**STAFF REPORT: CITY OF TRINIDAD**

APPLICATION NO: 2013-07

PROJECT LOCATION: 54 North Westhaven Dr.

PROJECT DESCRIPTION: Design Review and Coastal Development Permit for (1) a 2,100 sq. ft. addition to an existing, 2-story, 3-bedroom, 1,650 sq. ft. primary residence and (2) replacement of a 1-story, 2-bedroom, 728 sq. ft. accessory dwelling unit with a 2-story, 2-bedroom, 1,320 sq. ft. accessory dwelling unit.

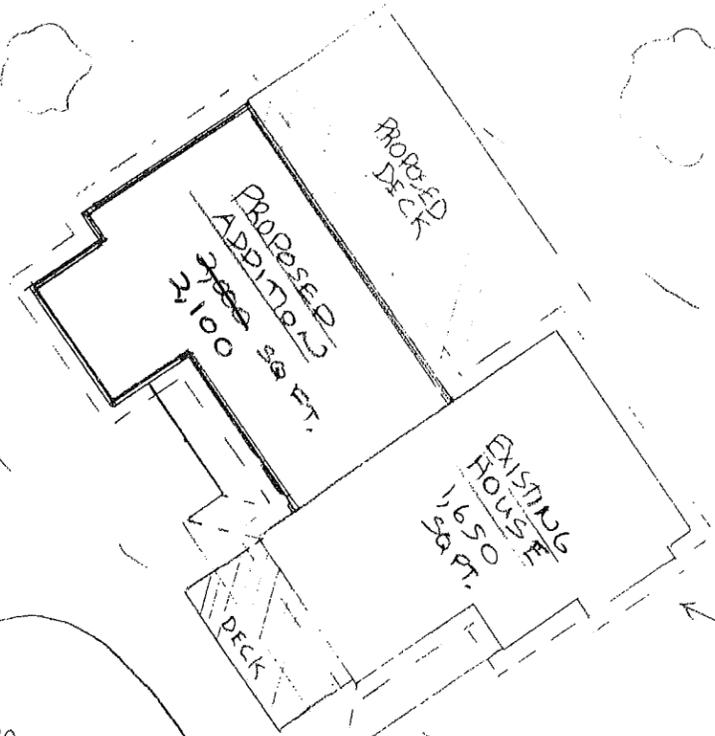
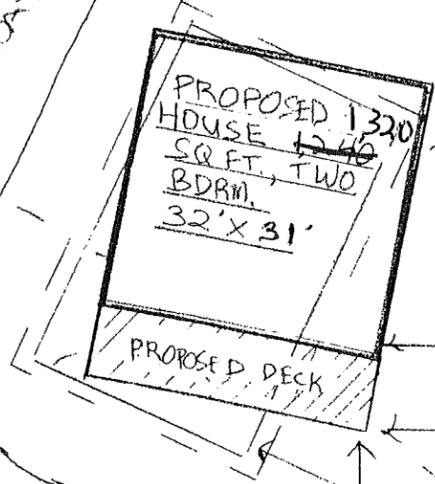
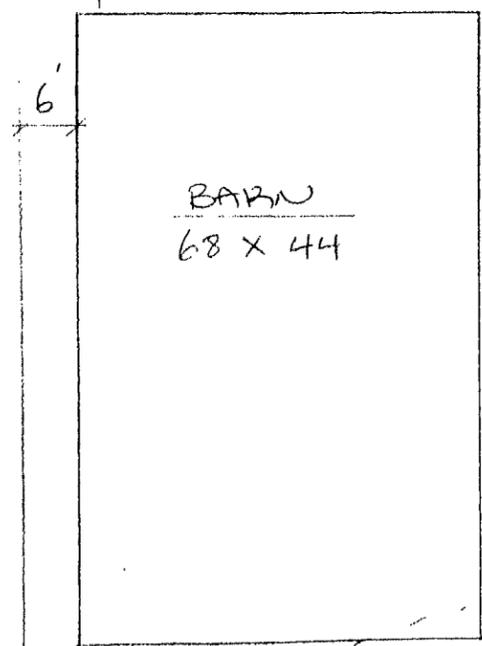
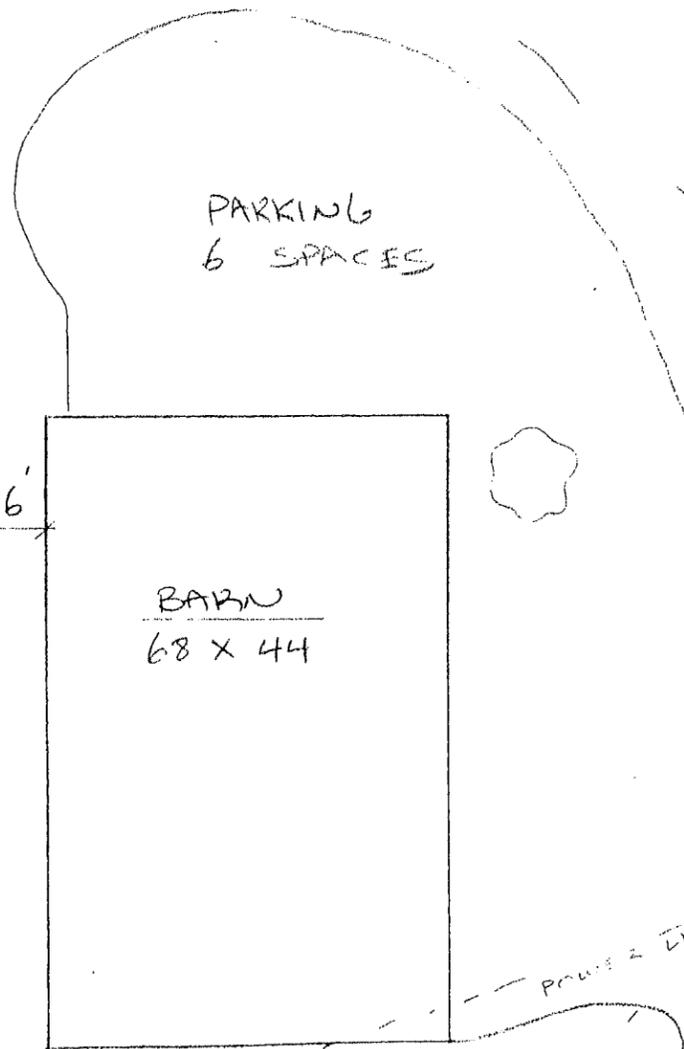
Required yards in the PD Zone for this type of project are the same as for the UR (Urban Residential) zone (§17.36.050): front – 20 ft.; rear – 15 ft.; and side – 5 ft. The required yards will easily be met by the proposed remodeled buildings as shown on the site plan, with the shortest distance to a property line being the existing 35 ft. side setback on the primary residence. Section 17.36.050 also states that the minimum yard between buildings shall be equal to the height of the higher building. The distance between the barn and the nearest building on the site—the accessory dwelling unit (ADU)—is 80 ft, and the distance between the ADU and primary unit (as measured to the front porch) will be approximately 30 ft. which complies, since the primary unit is also approximately 30 ft. in height (see below for more information). Architectural features such as eaves are allowed to extend up to 3 ft. into a required side yard, and the proposed structures will meet this requirement.

The elevations for the replaced accessory dwelling unit show the elevation to be 24.5 ft. in height, but that appears to be measured from the highest ground elevation. The site plan also states that the proposed ridge at the northeast corner will be 24.5 ft. in height. Based on the scaled elevations, it appears that the ridge height is closer to 25.5. or 26 ft. in height above the average ground elevation covered by the structure, which slightly exceeds the maximum height limit. Exceeding the height limit would require a variance to be approved by the Planning Commission. There doesn't seem to be a need to exceed the height limit in this case, and the roofline could easily be lowered by lowering the pitch of the roof or by additional grading for the foundation. Therefore, this has been included as a condition of approval.

- d. Maintaining natural drainage conditions*Responsibility: Building Official to confirm at time building permits are issued.*
  9. The accessory dwelling shall not be taller than 25 ft. from the average ground elevation under the building, and the height of the addition to the primary unit shall not exceed the roofline of the existing structure. *Responsibility: Building Official to verify prior to building permits being issued and during construction.*

PROPOSED  
SECOND FLOOR  
1100 SQ. FT.

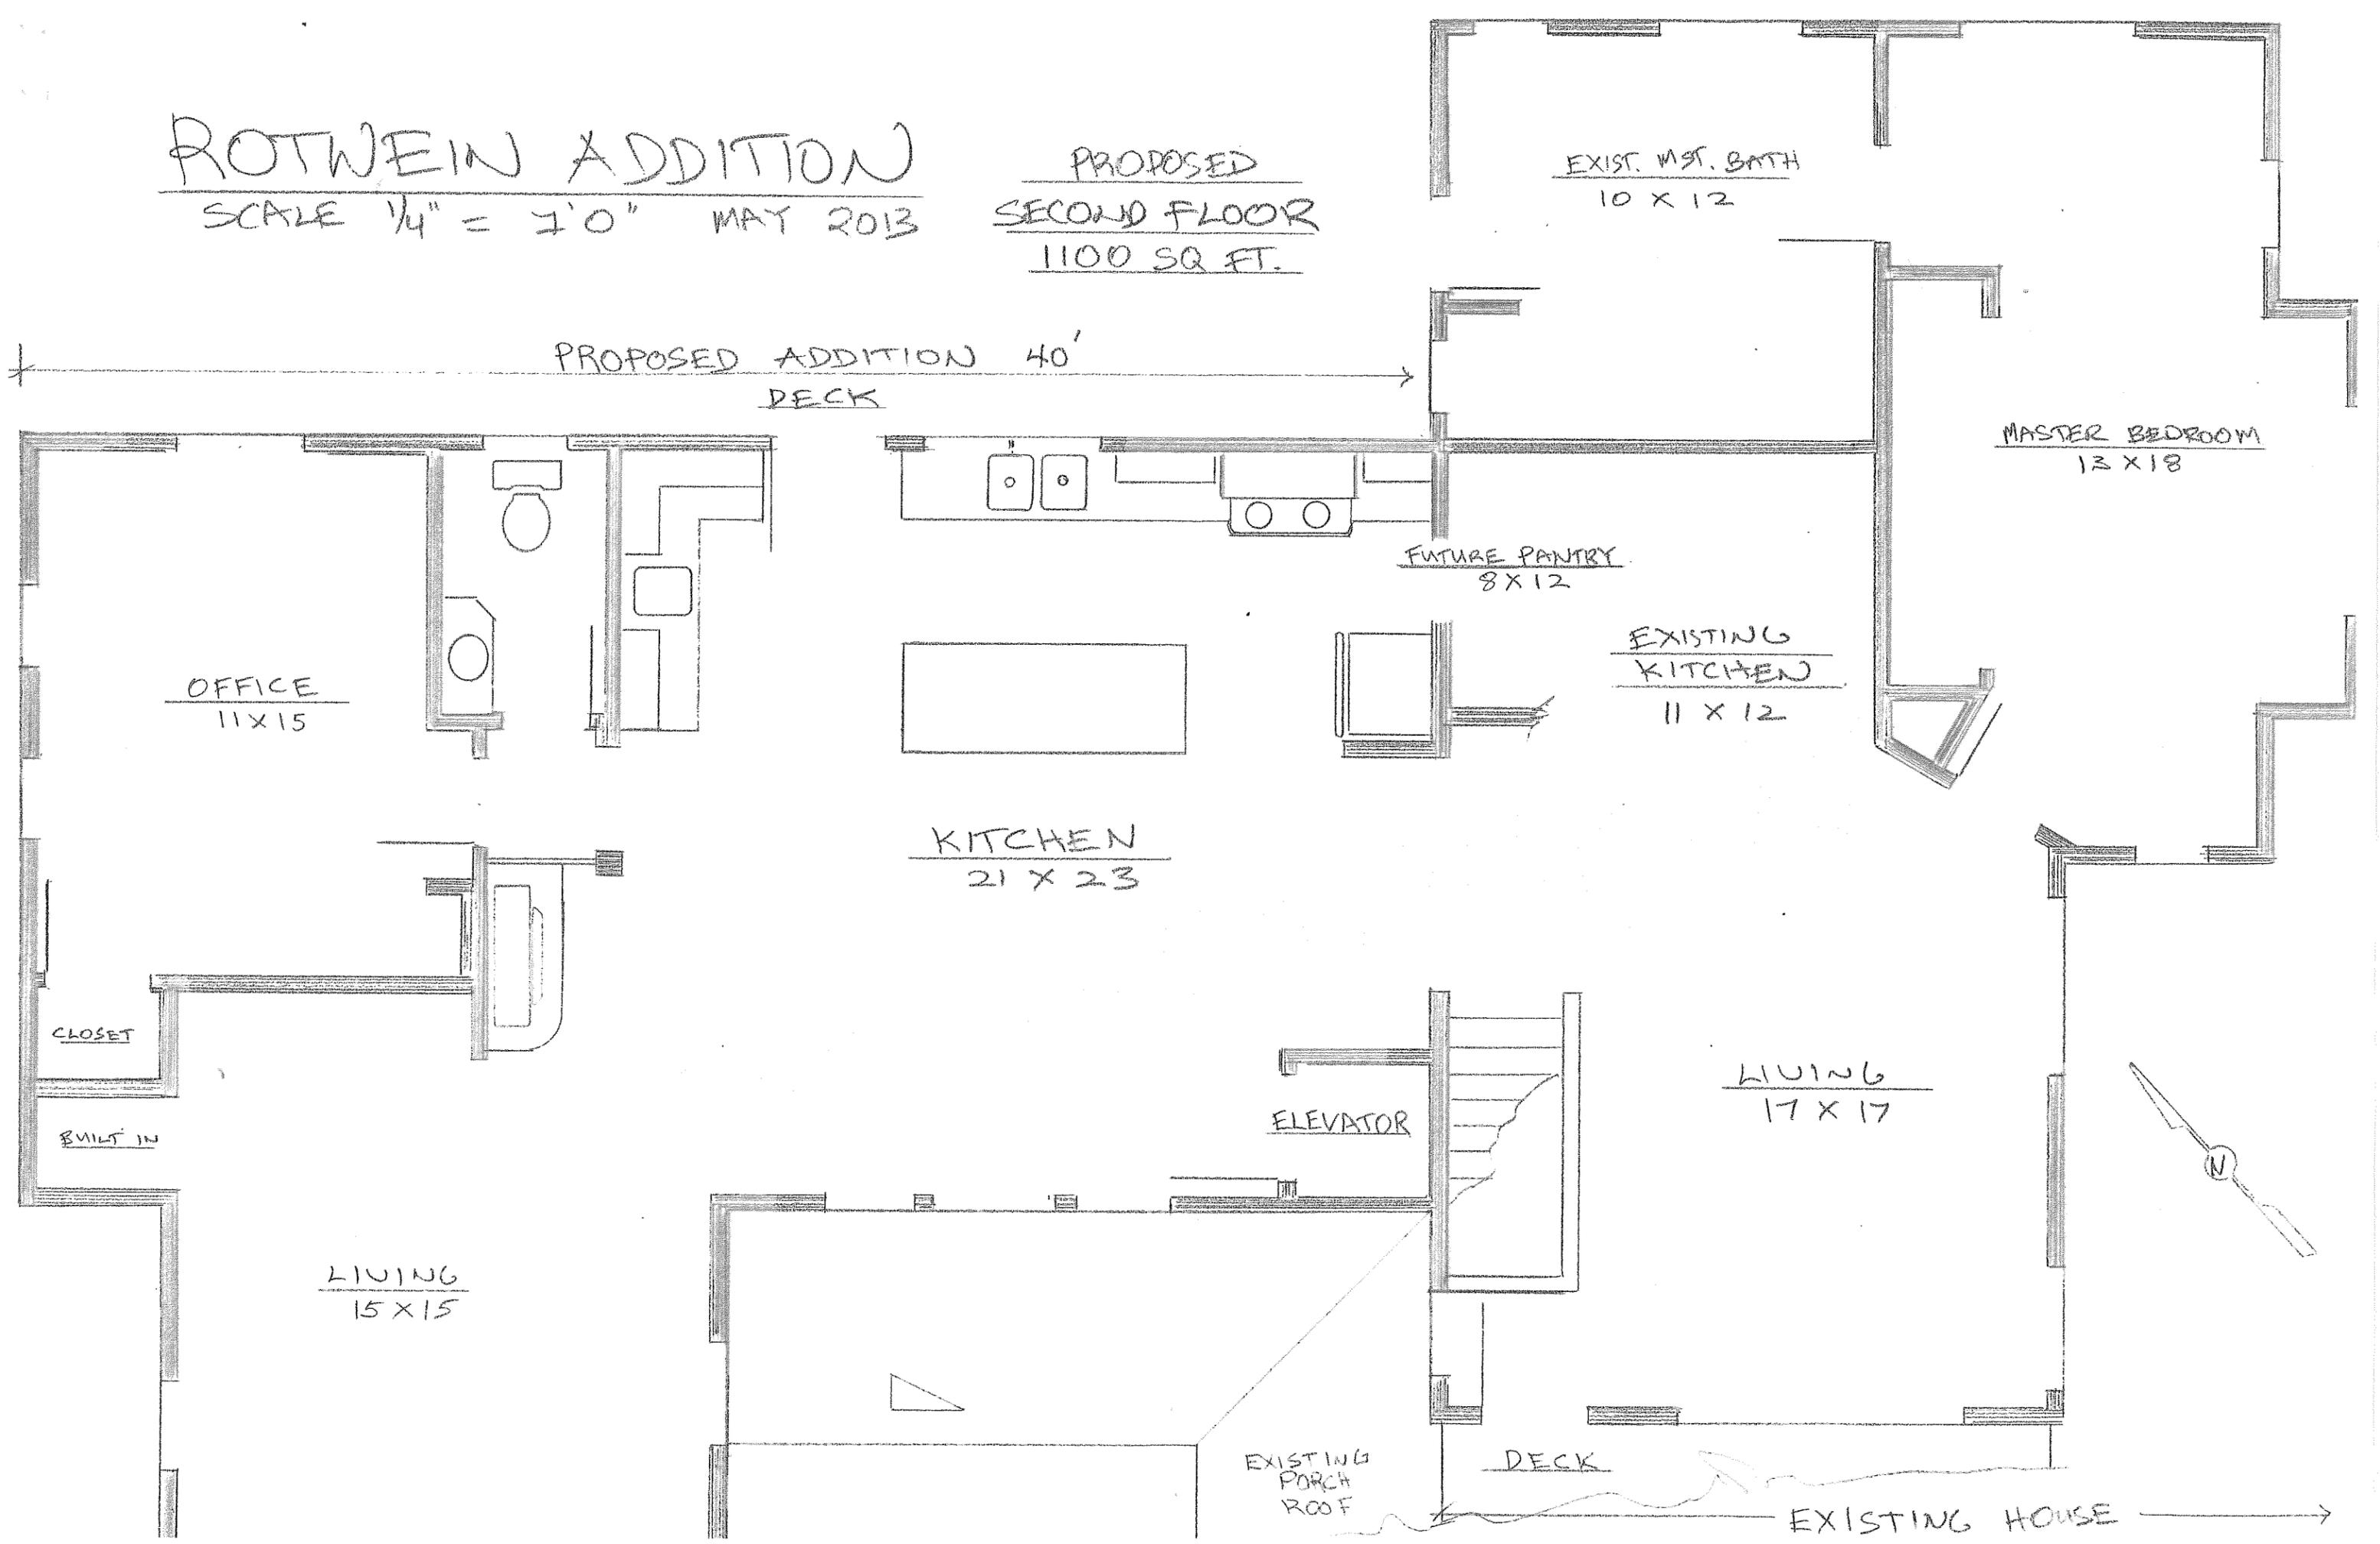
property in terms of the OWTS. In addition, although the applicants state that the primary residence will remain 3-bedrooms, the footprint and square footage is being more than doubled. At a minimum, the proposed office on the second floor would meet both the City's, County's and Building Code's definition of a bedroom. Some of the new rooms on the first floor could also potentially meet such definitions. In response to a referral that was sent to them for this project, DEH responded that the *"applicant shall provide certification from a qualified onsite wastewater treatment system designer indicating that the existing onsite treatment system is sized to current standards for the total number of bedrooms resulting from the proposed development."* This puts the burden on a professional to show that the OWTS meets current standards for the proposed project, and the applicants will need to work closely with DEH to meet their requirements. Due to the configuration of the office and the size of the addition, City staff is also specifying that the OWTS must, at a minimum, be designed to accommodate a 4-bedroom primary residence and 2-bedroom accessory dwelling unit. This is because, at 3,750 sq. ft. and with the proposed number of rooms, this residence will likely be considered at least a 4-bedroom residence for the purpose of any future sale or future residents. This is not to say that the existing OWTS has to be expanded or upgraded; that will have to be determined between a qualified professional and DEH.

3. Applicant shall provide certification from a qualified onsite wastewater treatment systems designer indicating that the existing OWTS is sized to current standards for the total number of bedrooms resulting from the proposed development (at least 4 for the primary and 2 in the accessory unit, 6 total) to the satisfaction of the DEH or obtain a sewage disposal permit from DEH for the necessary alterations to the existing system to accommodate the proposed development. The system must
